ADDENDUM NO.: 01

Service Center Warehouse Addition
Dassault Falcon Jet

Dassault Falcon Jet Hangar 12 Service Center Warehouse addition- PRE BID RFI LOG

Addenda #1

E102

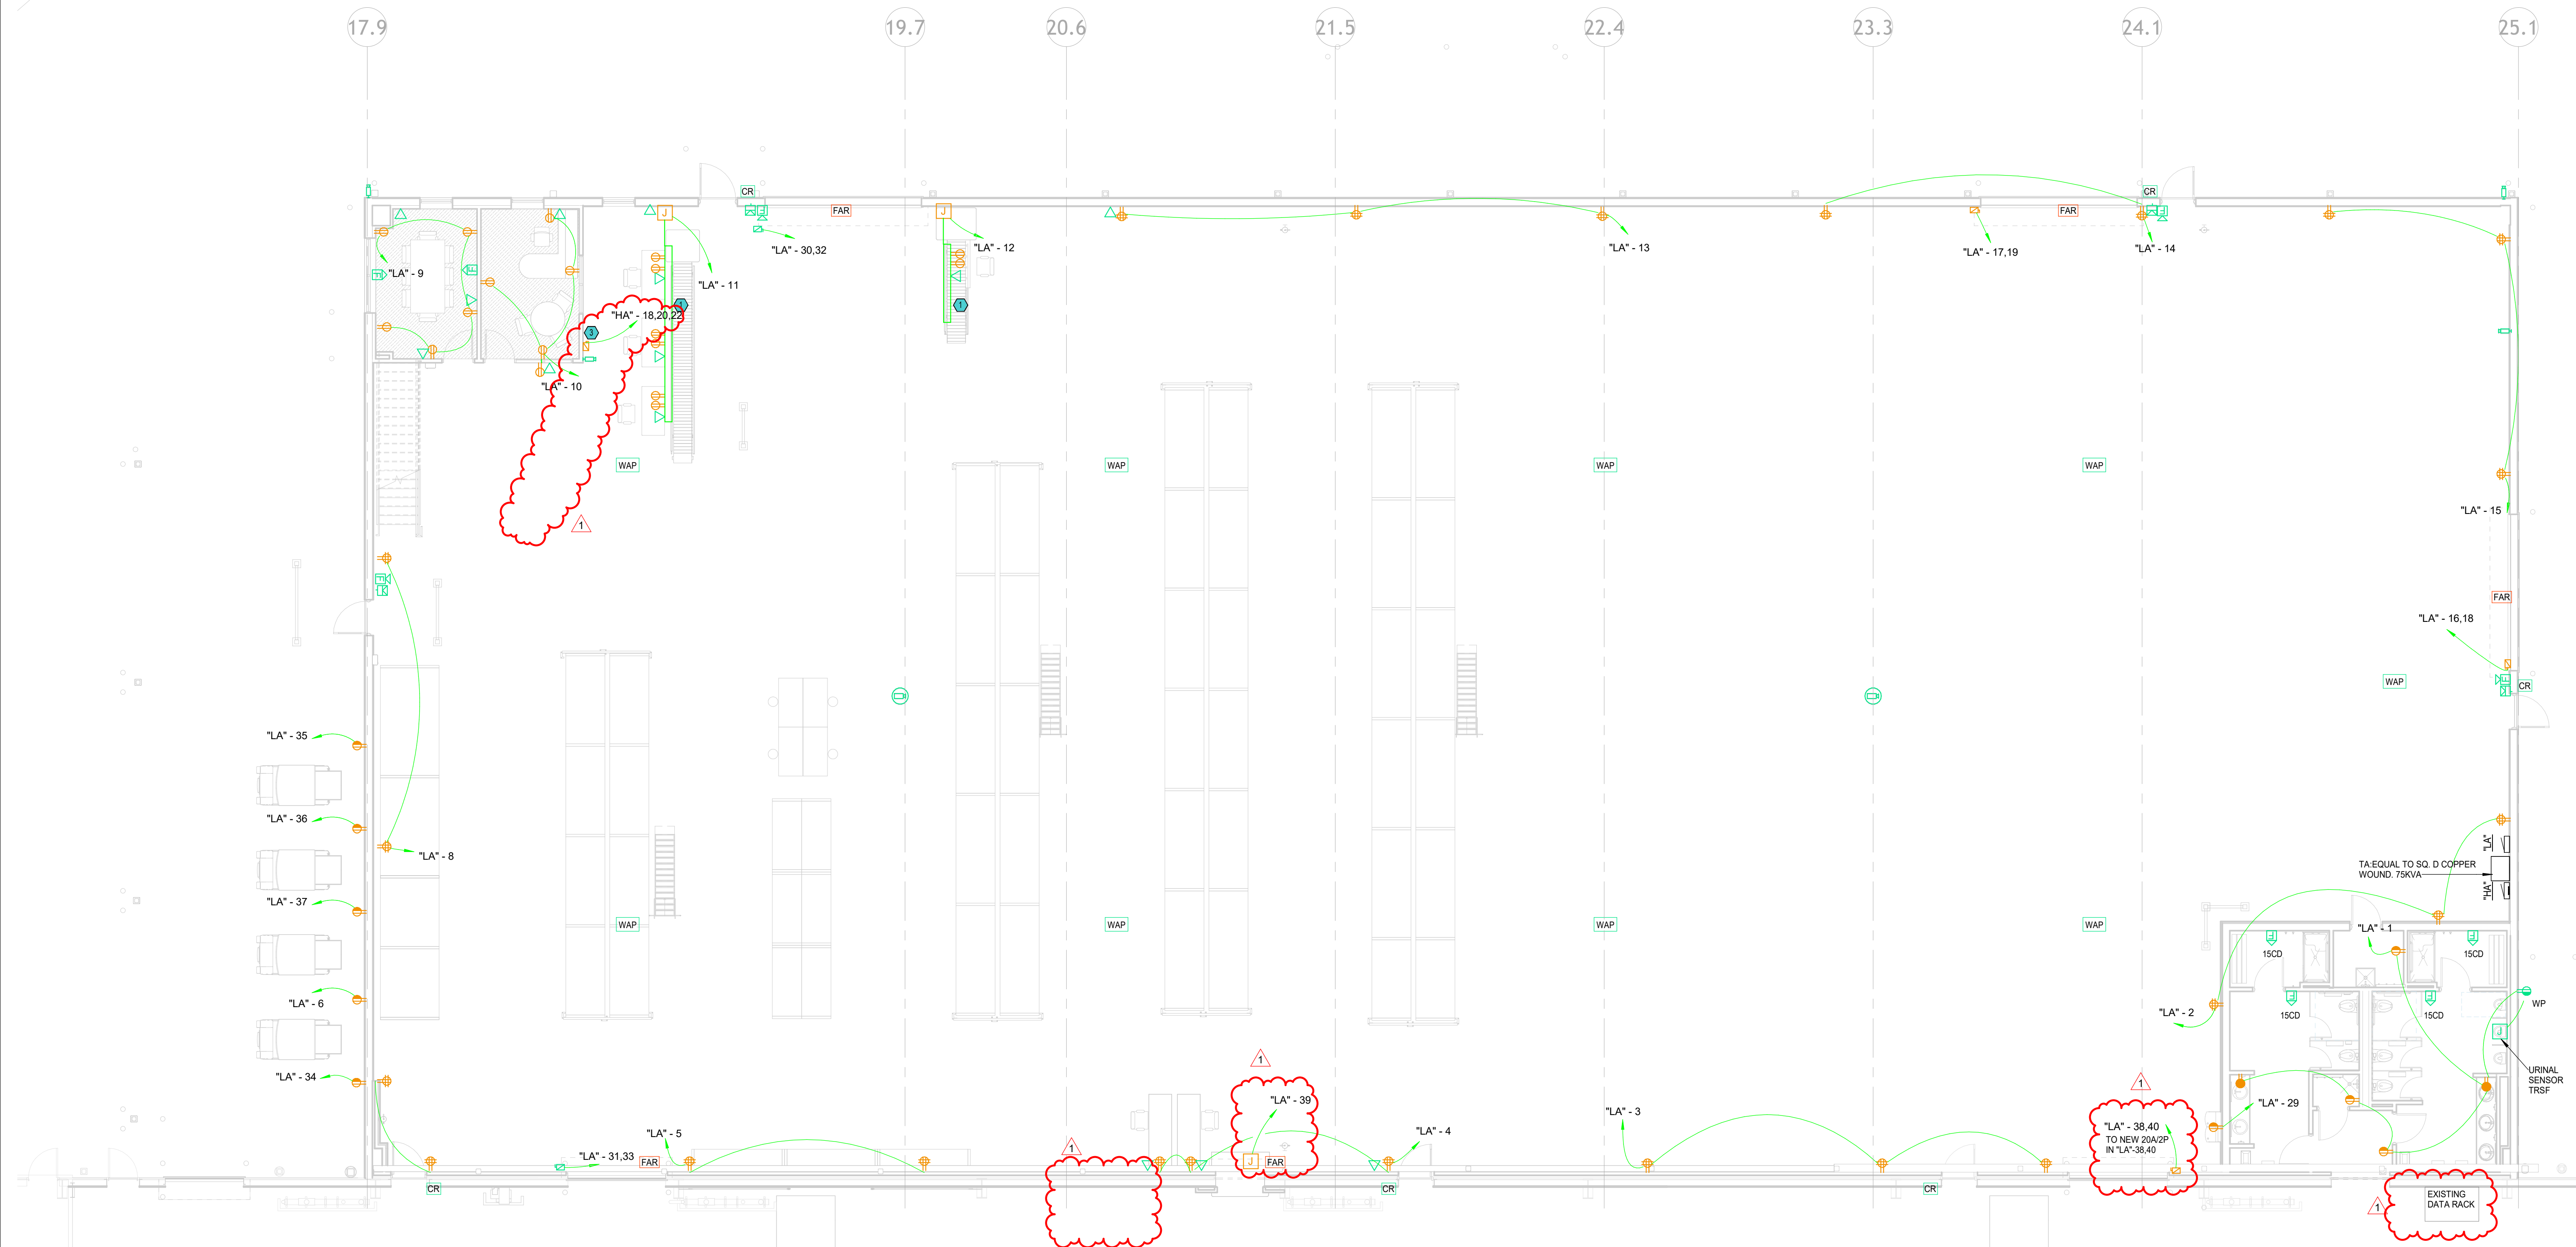
15	2026.10.14	E1.02 shows a mezzanine Elevator. Is this by the Owner and can you provide more information regarding the location and feed for the power/disconnect?	The Mezzanine Elevator is to be owner provided in the future. Contractor to provide power and disconnect only in this project scope. See revised E102 drawing Add 1 for disconnect location. Confirm final location with Owner prior to installation.	Oct 16 2026	Cpruit/PSW/ TLB/insight	TMcGee/Baldwinshell
16	2026.10.14	Can the Bid Form be submitted electronically? Or, does it need to be hand delivered?	Yes, bids may also be submitted by email to Ryan Roy at DFJ directly. (ryan.roy@dassaultfalconjet.com). It is the bidders responsibility to confirm receipt of the email by Ryan prior to the bidding deadline.	15-Oct-26	Cpruit/PSW	TMcGee/Baldwinshell
17	2026.10.14	Please commm whether non-U.S. citizens who are regany/ authorized to work in the	Yes, they may work on this project as long as they are authorized to work in the US and can pass the standard requirements that US citizens are	15-Oct-26	Cpruit/PSW	TMcGee/Baldwinshell

1. Refer to Sheet E102 – FLOOR PLAN – WAREHOUSE ADDITION POWER AND SYSTEMS
 - A. Relocated lift disconnect.
 - B. Relocated Existing Data Rack
 - C. Added 120V connection at small fire door.
 - D. Added circuit for new overhead door near Restrooms.
